Plan Commission

Agenda

Monday, January 27, 2020

SHEET NO.
C1.0

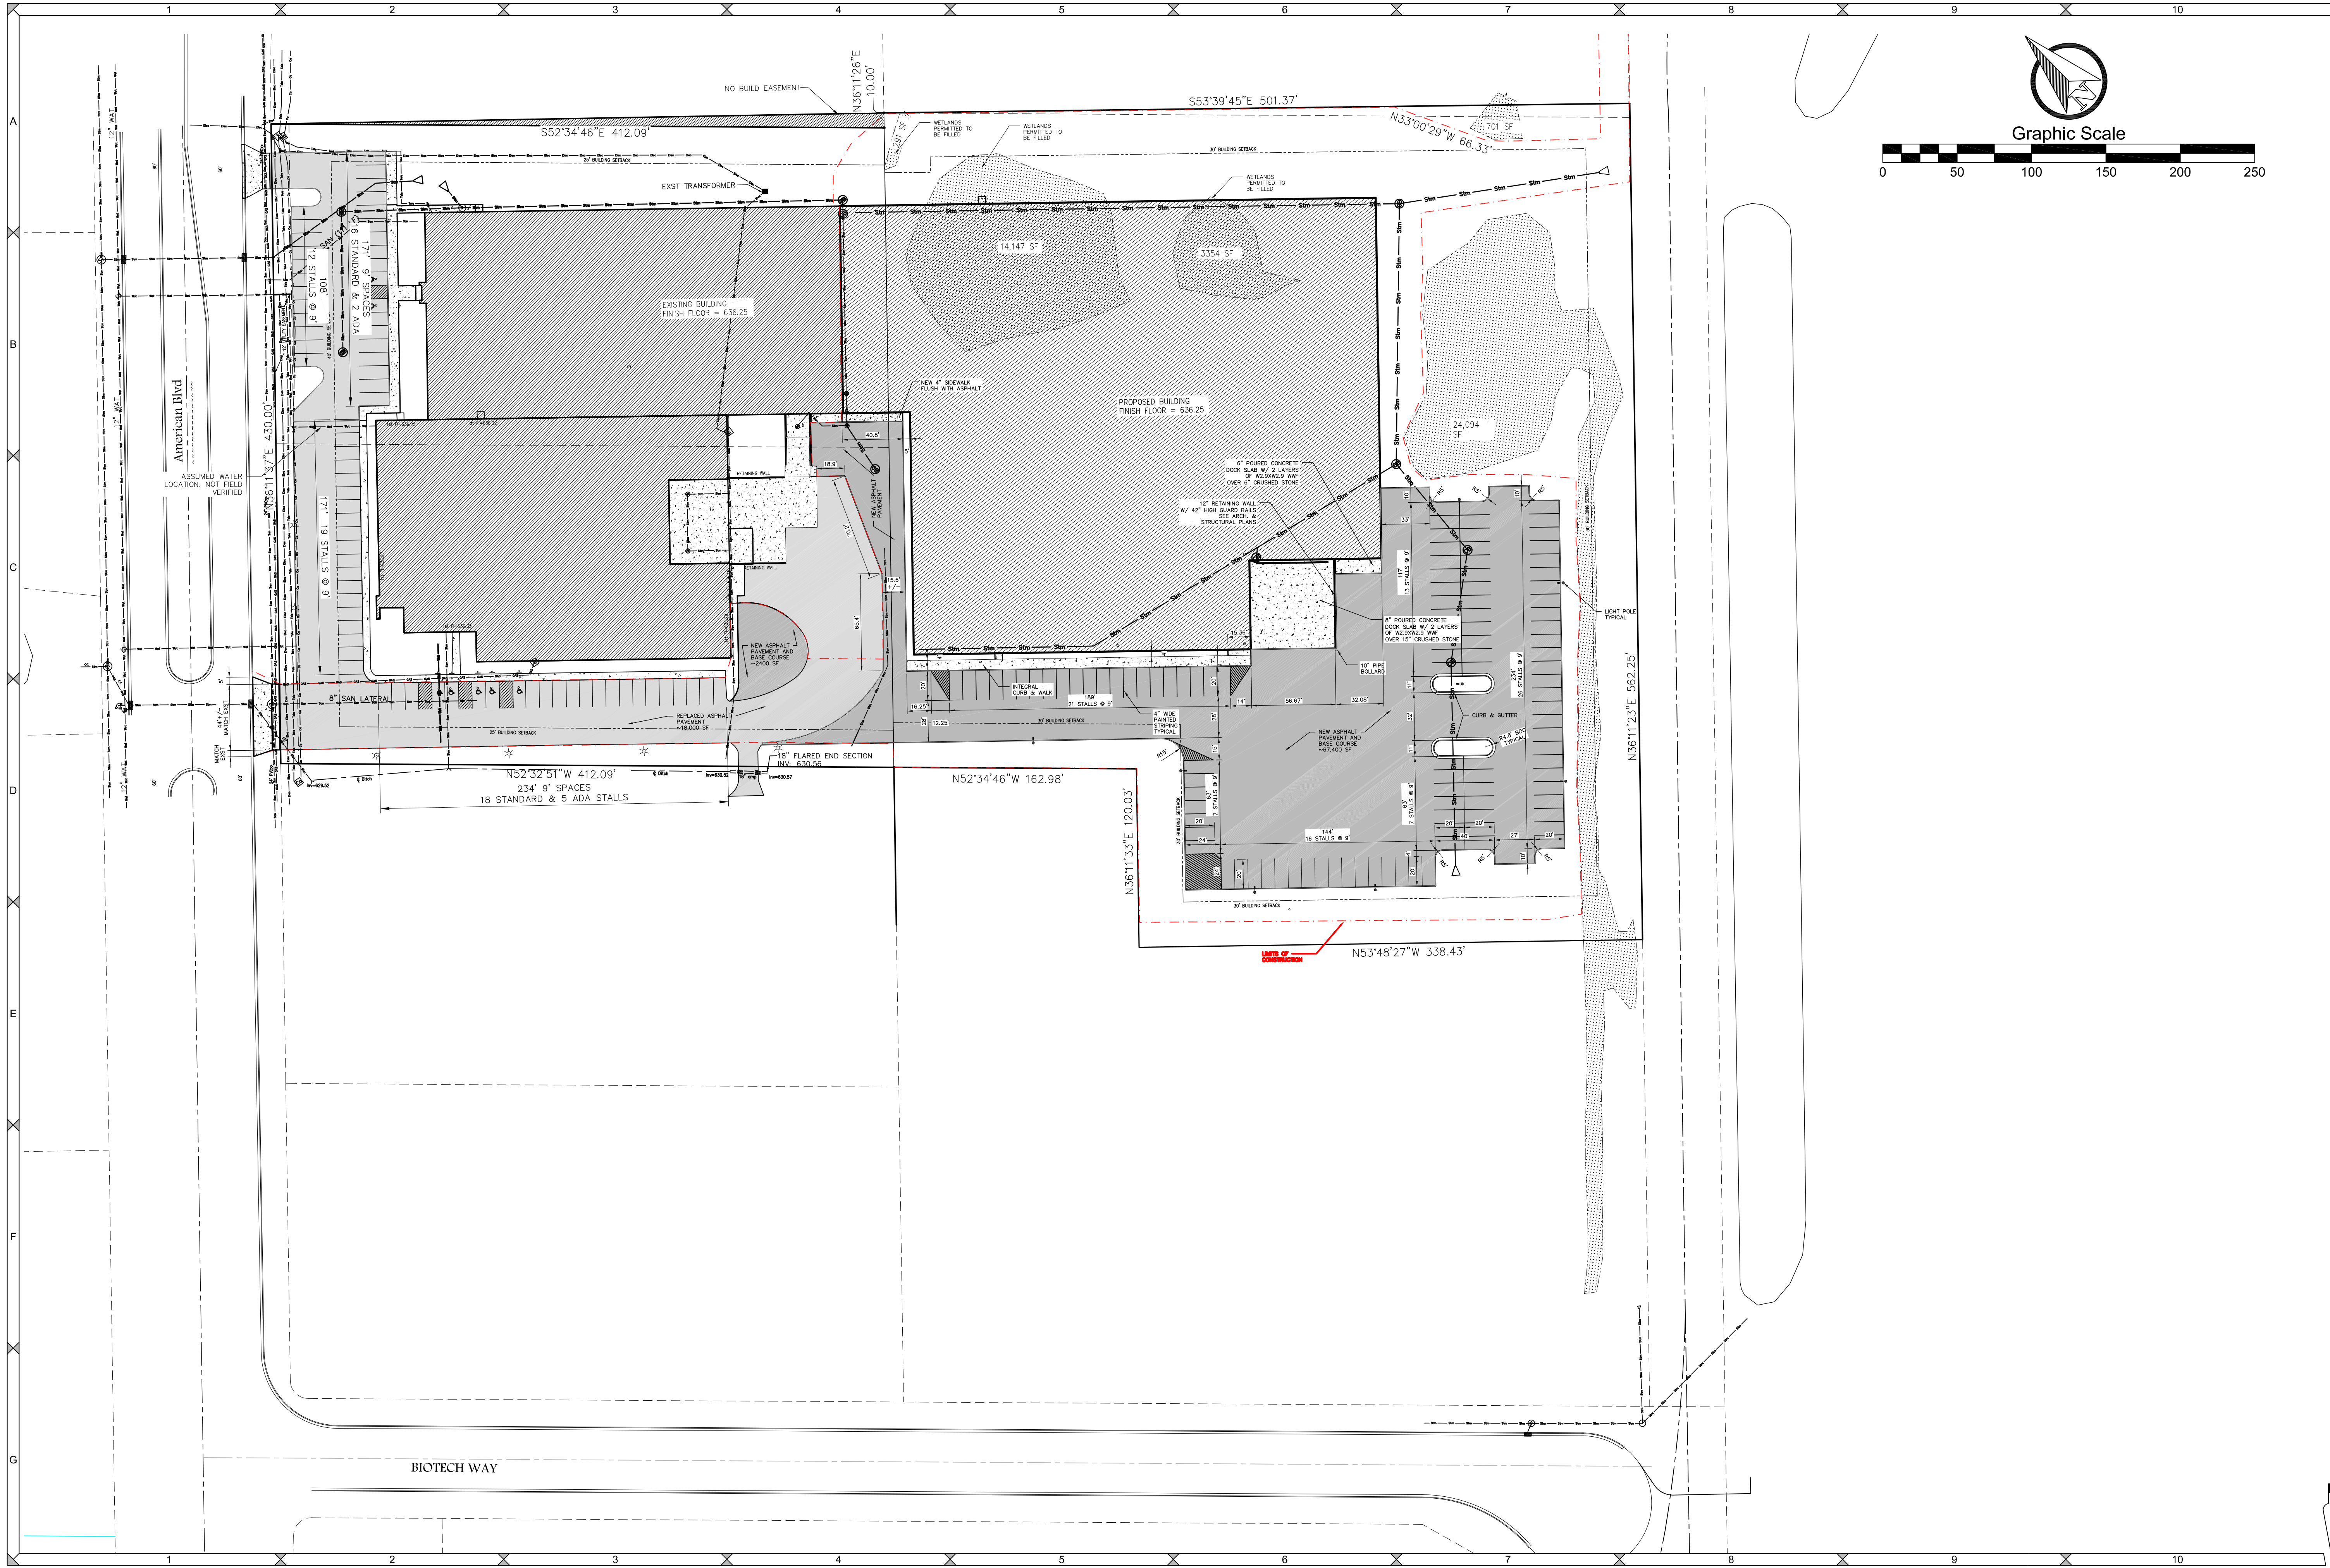
Sheet C2.0: The southern driveway falls within the project construction limits. If touched, this driveway will need to be repoured with 8-inch concrete and a 5-foot sidewalk section 6-inches off the right-of-way line. If this driveway is to be replaced, please add the following note to the sheet: "Concrete Workers License is required for any concrete work within the City of De Pere right-of-way. Concrete Worker License can be obtained at City of De Pere Public Works at 925 S. Sixth Street 920-339-4061.	Yes the driveway will be replaced at the width it currently exists at with the new concrete detail as requires. See detail C2.1.

Sheet C2.0: Is the curb and gutter on American Boulevard being touched?	Yes, curb is sawcut for new concrete drive flair as needed
Sheet C2.1: Provide an updated parking stall table showing site requirements and that ADA requirements are being met.	Parking calc shown on L1

SHEET NO.
C2.0

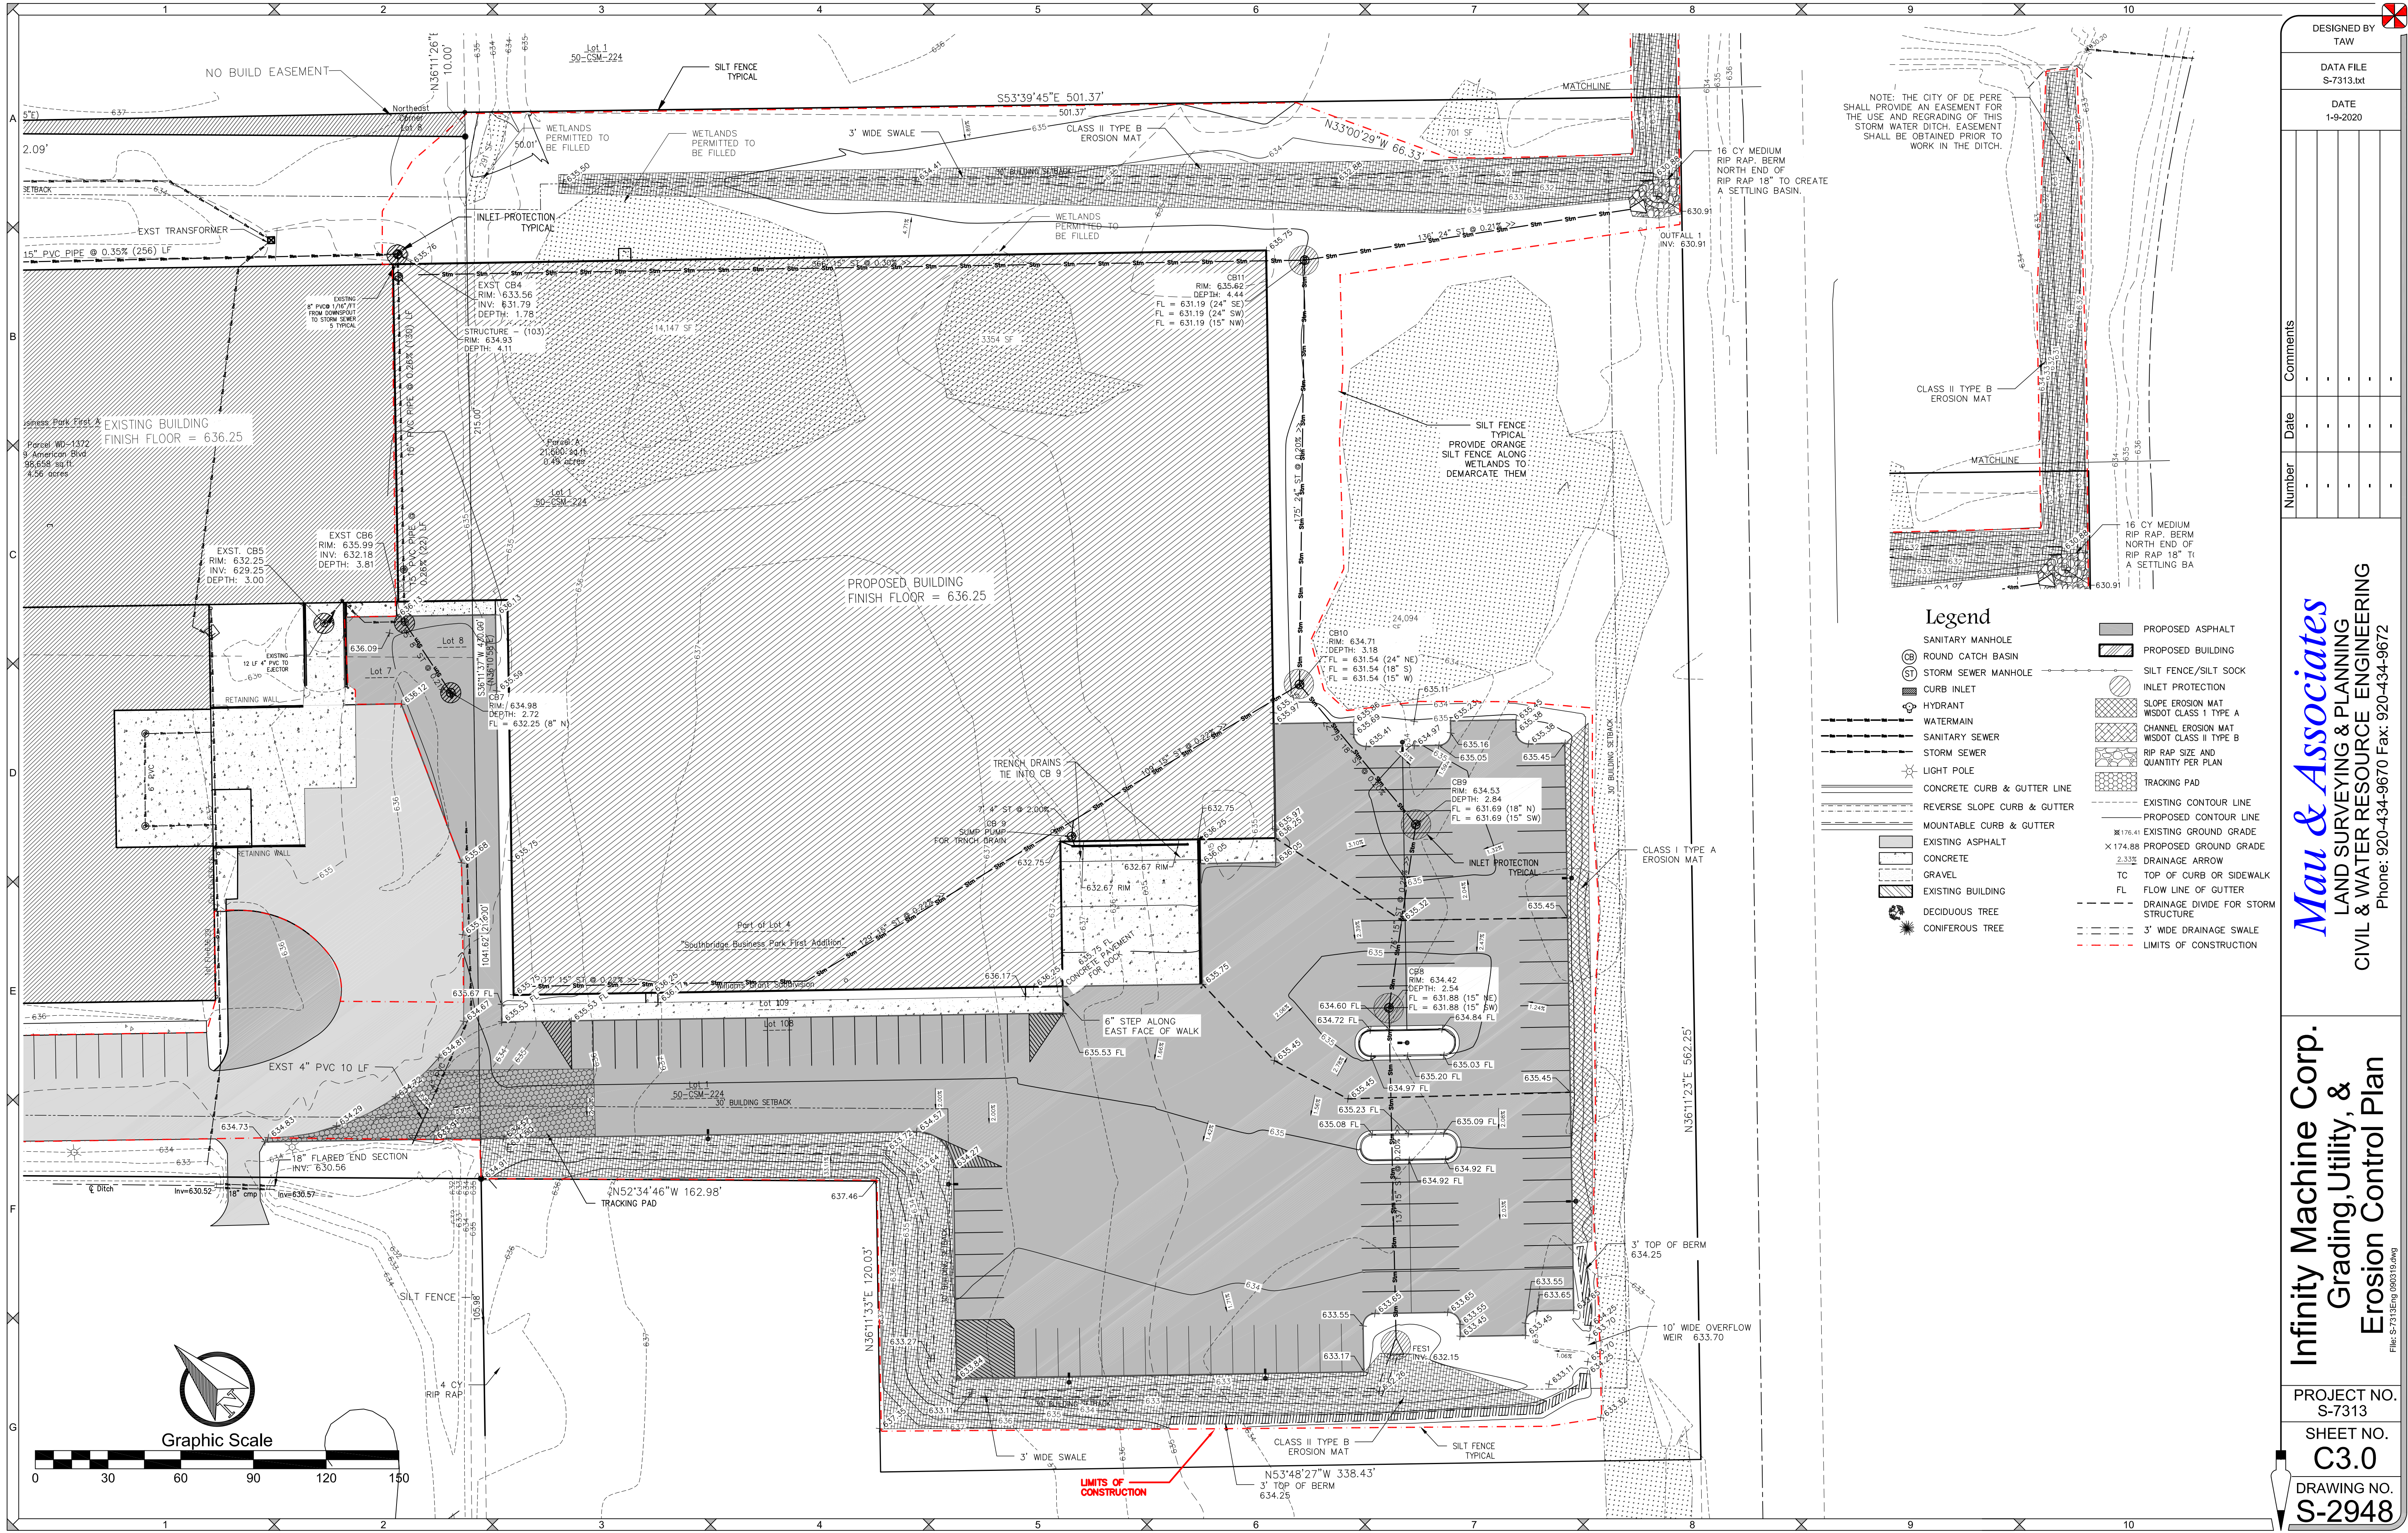
Sheet C2.1: Please confirm that site sanitary sewer and water service is being extended via internal plumbing.	Yes sanitary and water extended internally – note added C2.1 Fixed storm pipe note on C3.0

REVISION DESCRIPTION
							NO.
DATE: DECEMBER 2, 2019							
DRAFTED BY: TM / RPH							
CHECKED BY:							
PROJECT NO.: 0336-20-19							
DRAWING NUMBER							
SHEET NUMBER							
C4.2							
OF 15

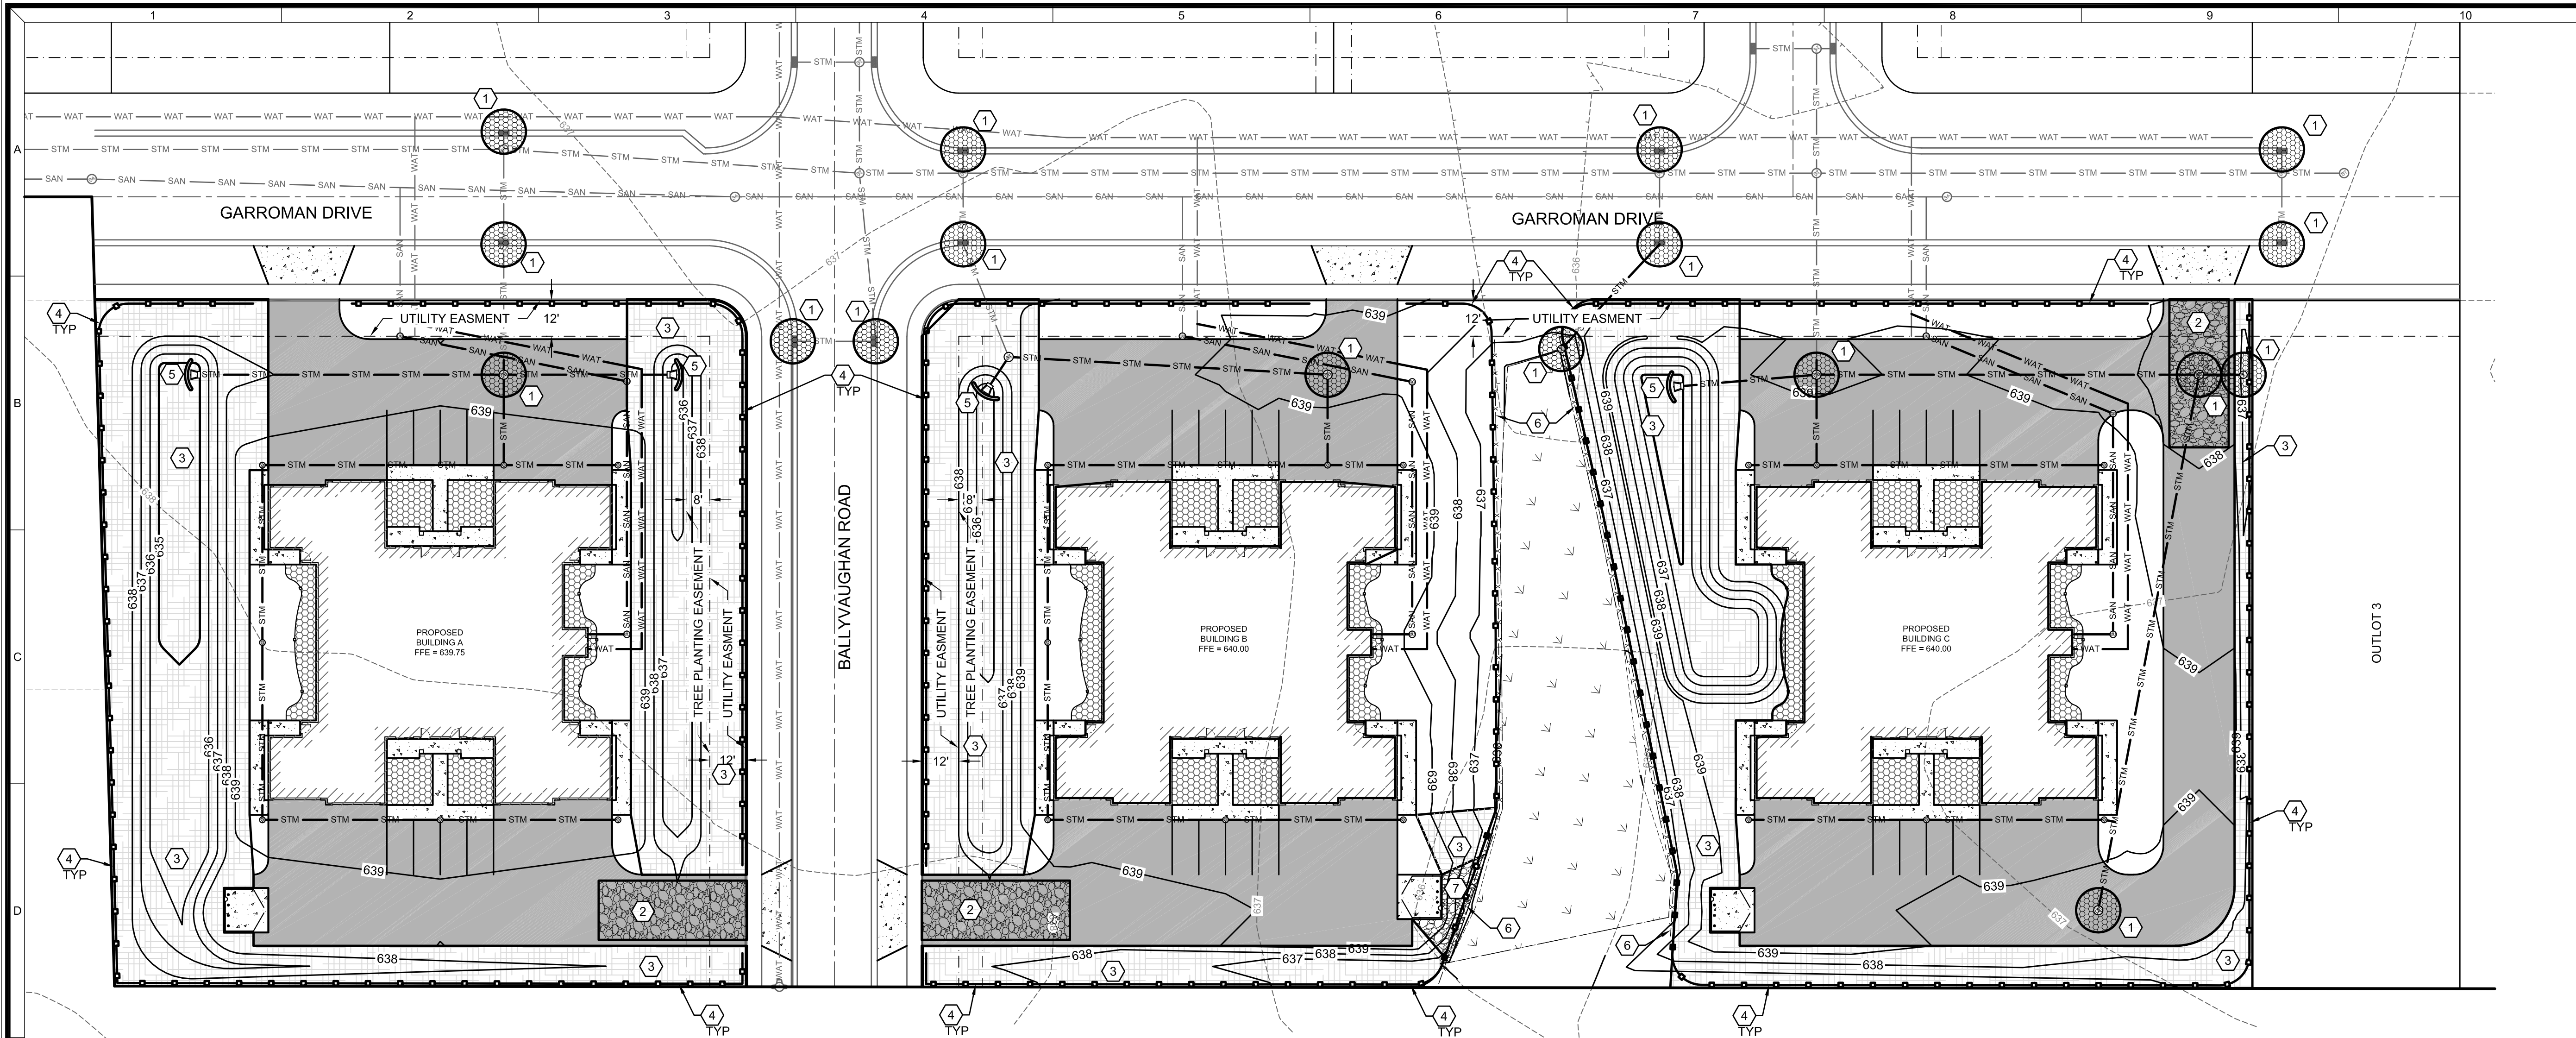
10. Sheet C4.2: Make a note that any concrete work in the right-of-way requires a concrete worker's license. Concrete Worker's Licenses can be obtained at the City of De Pere Department of Public Works 920-339-4061

11. Sheet C4.2: Is there spot grading in the wetland area?
 12. Sheet C5.0: Indicate stockpile locations as required by Construction note #1.
 13. Sheet C5.0: Construction sequence should be Winter 2020 to Fall 2021 not 2020.
